Schedule A

Deficiency Responses for Oroville Facilities Relicensing (FERC Project No. 2100)

Hyatt Pumping-Generating Plant Capability as a Function of Head at Maximum Discharge

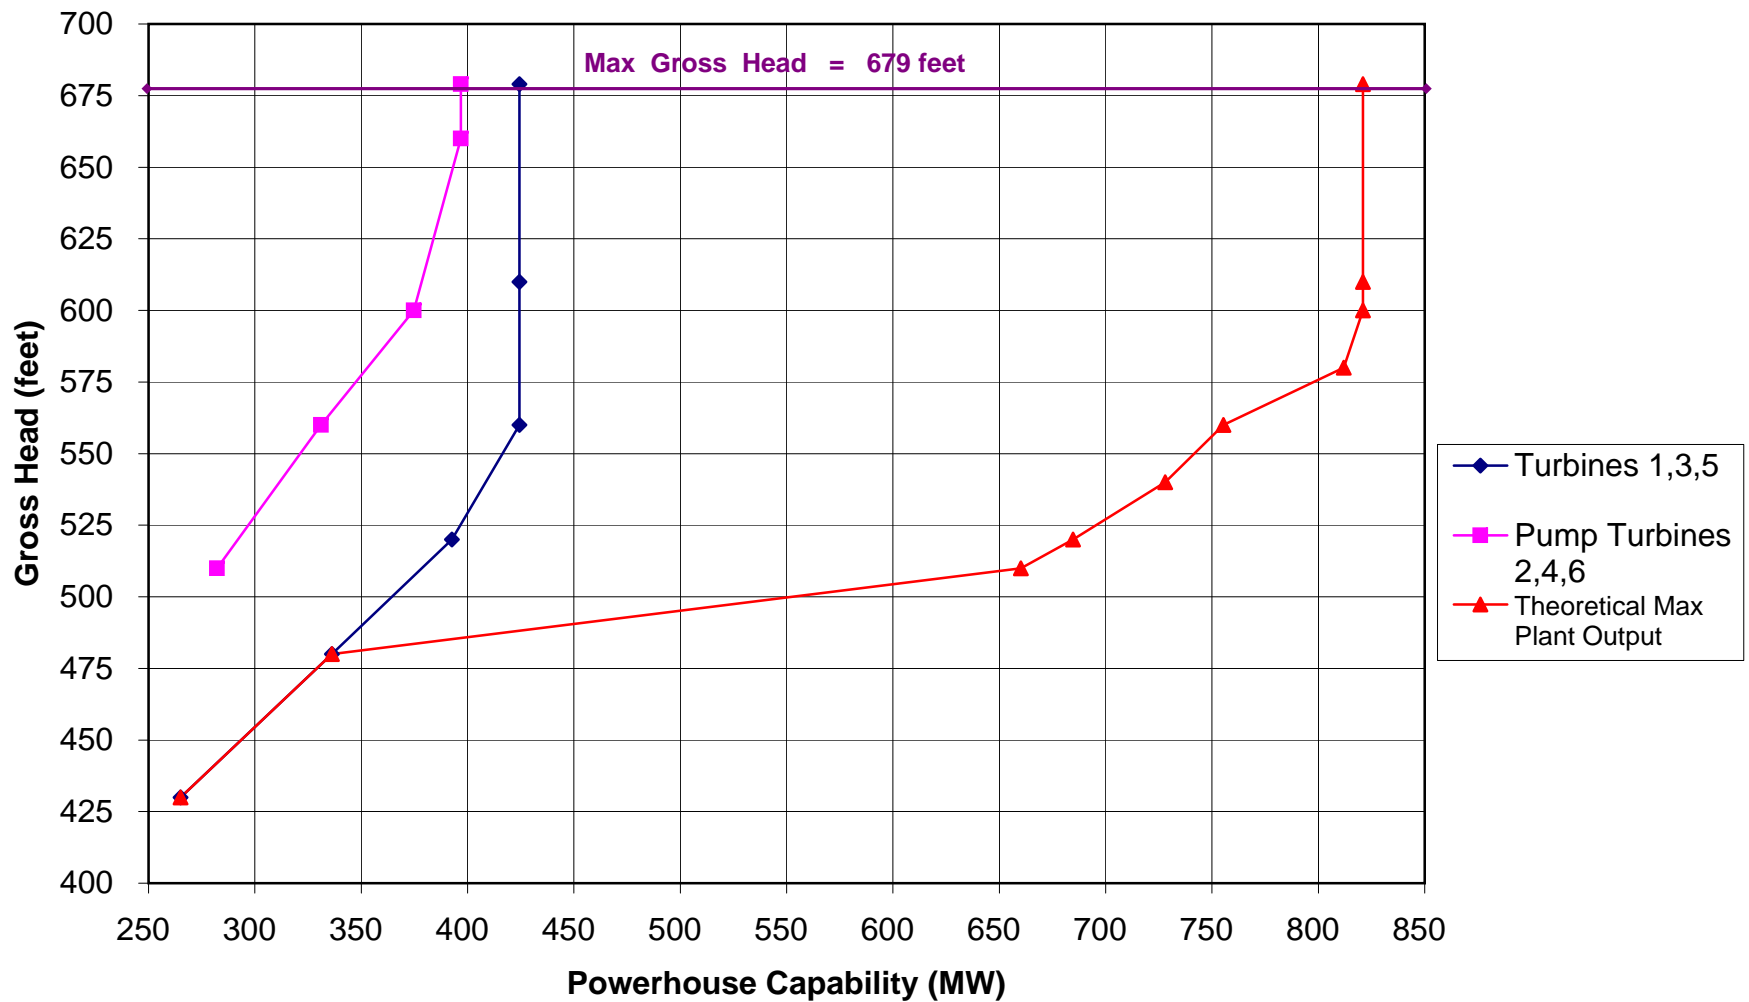
5. *18 CFR §4.51 (c) requires curves showing powerplant capability versus head and requires you to specify maximum, normal and minimum head. In Volume 1, Section 3 of Exhibit B, you provide a table showing the capacity at maximum, normal, and minimum head; however no curves were provided to show how the powerplant capability varies with head. Therefore, please provide such curves for each of the three power plants.*

Exhibit B of our License Application contains Table B.3.5-1 to provide information on the upper and lower bounds of output for each of the three Oroville Facilities' power plants. Individual plant performance curves were not available at the time of our filing. These curves have now been developed in response to your request. For the Hyatt Pumping-Generating Plant, the output curves reflect the turbine/generator performance test results from the efficiency testing conducted during 2004 subsequent to completion of turbine refurbishment work.

The power plant capability versus head curves are provided on the following pages.
